## SUNDRY NOTICES AND REPORTS ON WELLS

8. Well Name and No.  
HAHN FEDERAL 19. API Well No.  
30-005-2046610. Field and Pool or Exploratory Area  
TOM-TOM SAN ANDRES11. County or Parish, State  
CHAVES COUNTY COUNTY, NM

**Hahn Federal 1  
30-005-20466  
Cross Border Resources, Inc.  
April 2, 2018  
Conditions of Approval**

## Post Plug WBD

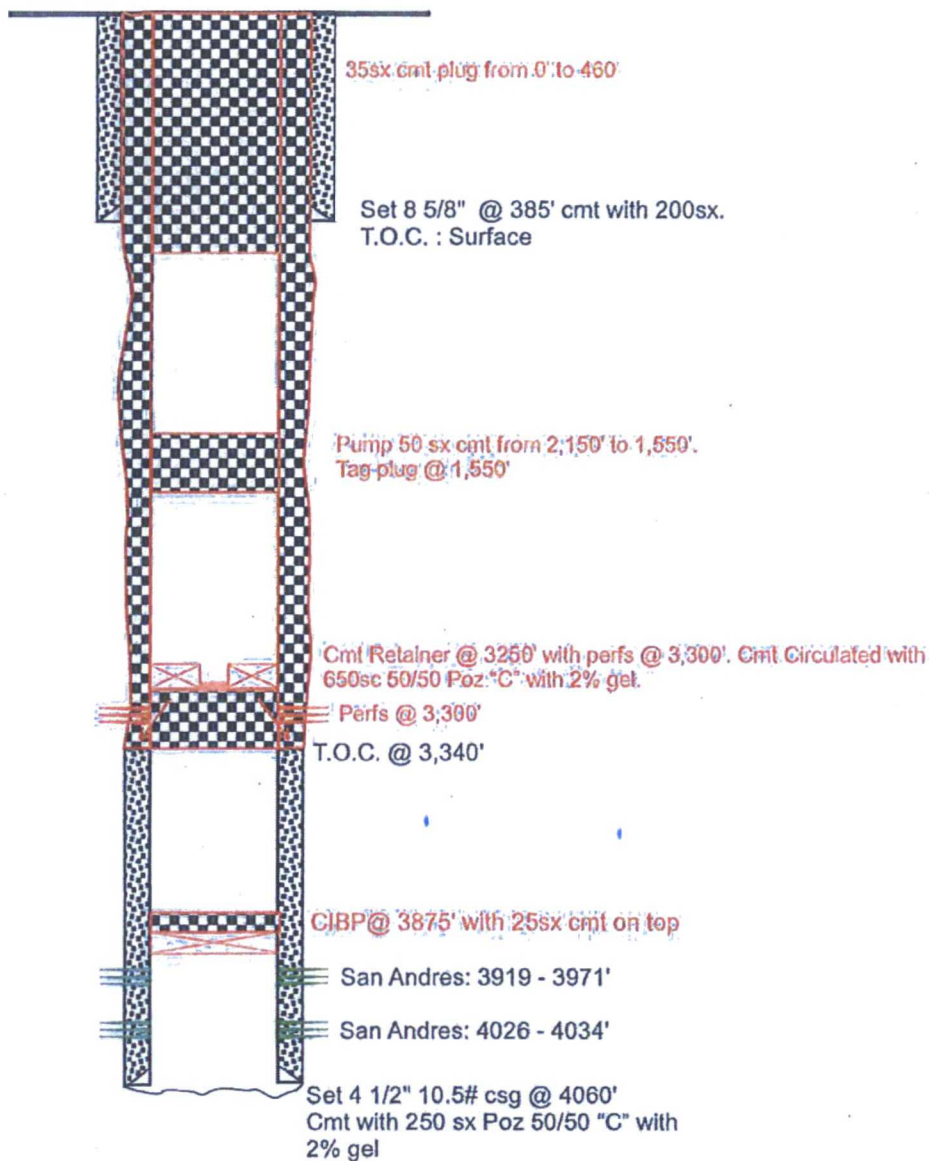
- 1. Operator shall place CIBP 50'-100' above top most perf and place 25 sx of Class C cement on top as proposed. WOC and TAG.**
- 2. Operator approved to perf and pump cement on the backside of casing as proposed. Operator shall provide method of verification. If circulation is not achieved to surface operator will need to contact BLM prior to continuing.**
- 3. Operator shall place a Class C cement plug from 2,150'-1,550' to seal the Yates Formation. WOC and TAG as proposed.**
- 4. Operator shall place a Class C cement plug form 460' to surface as proposed.**
- 5. See Attached for general plugging stipulations.**
